ENVIRONMENTAL PROTECTION AGENCY

Approval and Promulgation of Air Quality Implementation Plans; Wyoming; Revisions to Regional Haze State Implementation Plan; Revisions to Regional Haze Federal Implementation Plan

ACTION: Final rule.

Figure 1. Map Depicting Federal Class I Areas and Representative IMPROVE Monitors in Wyoming.

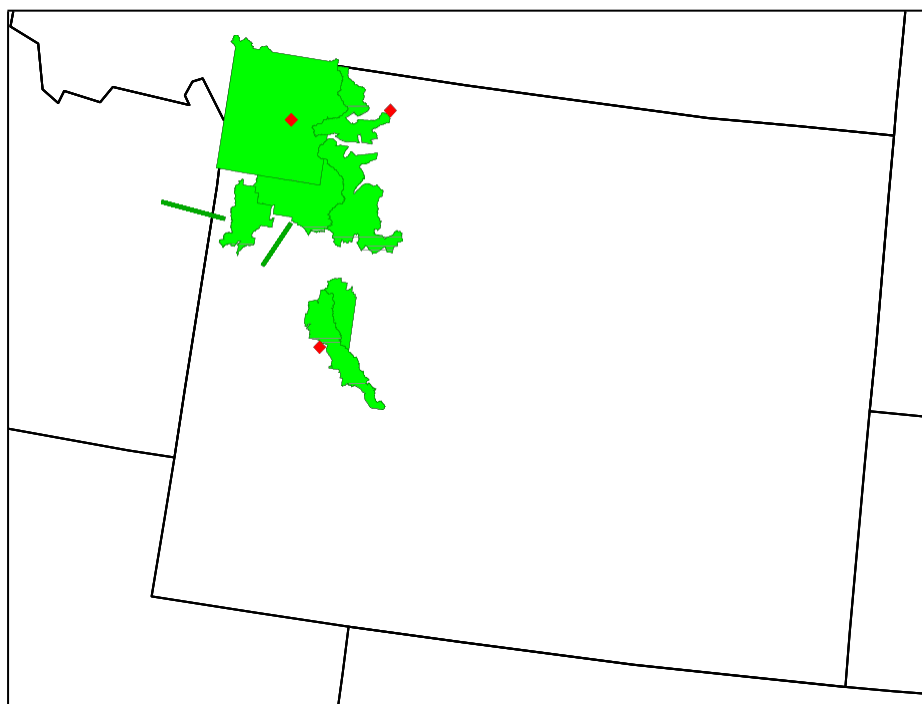
Comment: Finally, the commenters argue that multiple features of the EPA's modeling exacerbate the uncertainty inherent in CAMx and compound the unreliability of the results on which the EPA relies upon in its BART alternative determination, including:⁹⁸

Response: We disagree with the commenters' arguments that multiple features of our modeling, including large transport distances, lack of IMPROVE monitors, and the use of PSAT exacerbated the uncertainty inherent in CAMx and compounded the unreliability of the results on which we relied upon in our BART alternative determination. In fact, we utilized multiple tools, as discussed previously, to further evaluate the modeling results to determine whether the results represent "real" modeled visibility differences.

Specifically, it is true that in some geographic areas, single IMPROVE monitors represent multiple Class I areas, based on expected similarities between the airsheds (Figure 1). This approach is consistent with the EPA's Guidance for Tracking Progress Under the Regional Haze Rule that areas without a monitor are assigned a representative monitor,⁹⁹ and other requirements to include all Class I areas in the modeling domain.¹⁰⁰ Therefore, the Yellowstone IMPROVE monitor was used to represent several other Class I areas in the analysis. We note that the IMPROVE data from the nearby Class I area is used for the RRF correction for model bias for Class I areas that do not have a dedicated IMPROVE monitor. This nearby monitor approach is used by the EPA and states for all regulatory and planning requirements for Class I areas that lack IMPROVE monitors, and the estimates represent visibility improvements at these Class I areas.¹⁰¹ Furthermore, without data showing the monitors are not representative, we have no reason to find that this assumption should not apply.
